# 1966 Corvette: Service Bulletin: Automatic Choke Malfunction

**Bulletin No:** TSB #66-6, DR #66-6

**Date:** November 18, 1965

FIG. I - CHOKE THERMOSTAT ASSEMBLY - 283 V-8

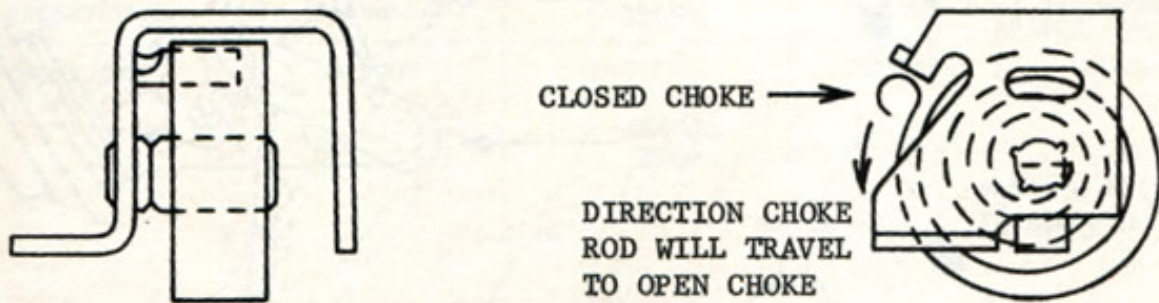
NOTE: Choke thermostat assemblies, although similar in appearance, are not interchangeable. Check bracket design as shown in Figures I, II and III and the coil spring identification number shown on chart (Number stamped in coil, not number in ink). Choke coil springs are indexed to bracket and must not be interchanged or repositioned.

FIG. II - CHOKE THERMOSTAT ASSEMBLY - 327 V-8 (275 HP)

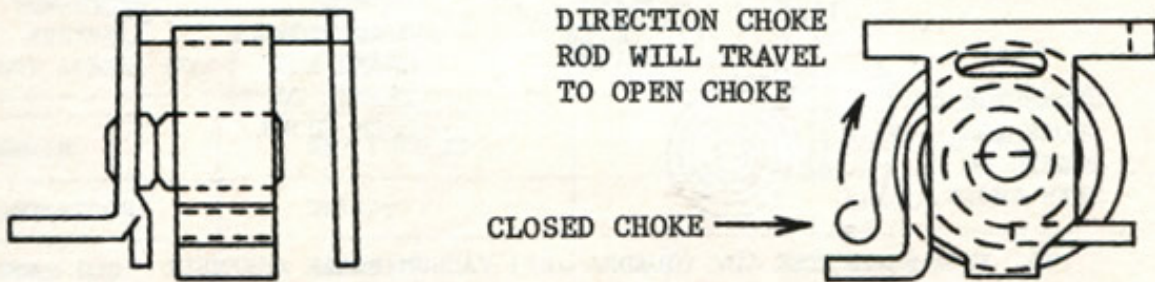
It should be noted that an important difference exists between the 327" (275 h.p.) engine choke operation and the remaining V-8 engines. That is, the direction of the thermostat operation between the two units is reversed. On the 327" (275 h.p.) application, the eye of the thermostat coil and the corresponding choke rod travels from a down position for closed choke relaxing upward for open choke. On the remaining V-8 engines (except 283 4

FIG. IV - ROCHESTER 4MV (QUADRA JET) VACUUM BREAK ASSEMBLY

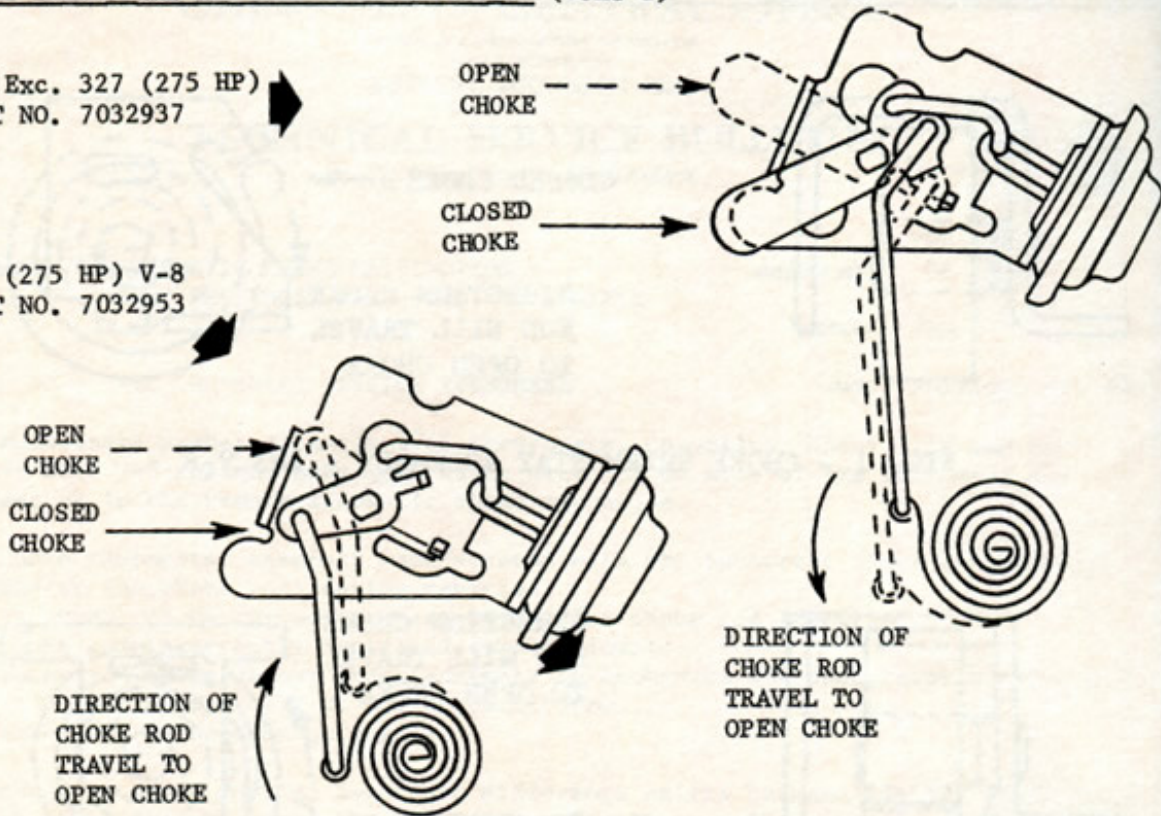
1. Choke thermostat assembly manufactured with the incorrect choke coil spring and/or the choke coil spring reversed.
2. Incorrect choke thermostat assembly and/or choke rod installed.
3. Choke rod incorrectly installed (upside down).
4. Incorrect choke vacuum break assembly on Rochester 4MV carburetor (Quadrajete).
5. Incorrect choke lever on Holley carburetor.
6. Incorrect carburetor on engine.

V-8 Exc. 327 (275 HP)  
PART NO. 7032937

327 (275 HP) V-8  
PART NO. 7032953

1. Remove carburetor air horn as outlined on Page 6M-25 of the 1966 Chassis Overhaul Manual.
2. Remove retaining screw from choke vacuum break assembly, then remove assembly.
3. Remove choke lever from float bowl well.
4. Install choke vacuum break assembly as outlined on Page 6M-27, Steps 5, 6, and 7 of the 1966 Chassis Overhaul Manual.
5. Install carburetor air horn as outlined on Page 6M-29 of the 1966 Chassis Overhaul Manual.

FIG. V - HOLLEY CHOKE LEVER AND VACUUM BREAK ASSEMBLY

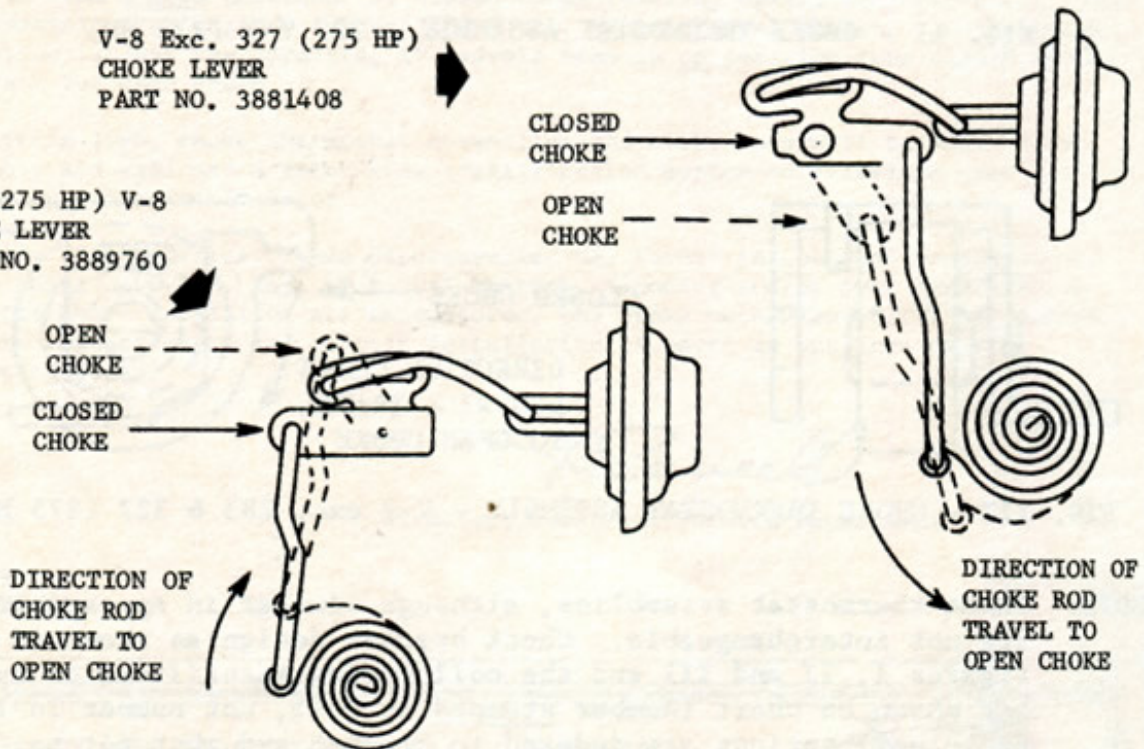
V-8 Exc. 327 (275 HP)  
CHOKE LEVER  
PART NO. 3881408

327 (275 HP) V-8  
CHOKE LEVER  
PART NO. 3889760

Disconnect choke vacuum break link, then remove choke lever retainer and choke lever. Reverse procedure to replace.
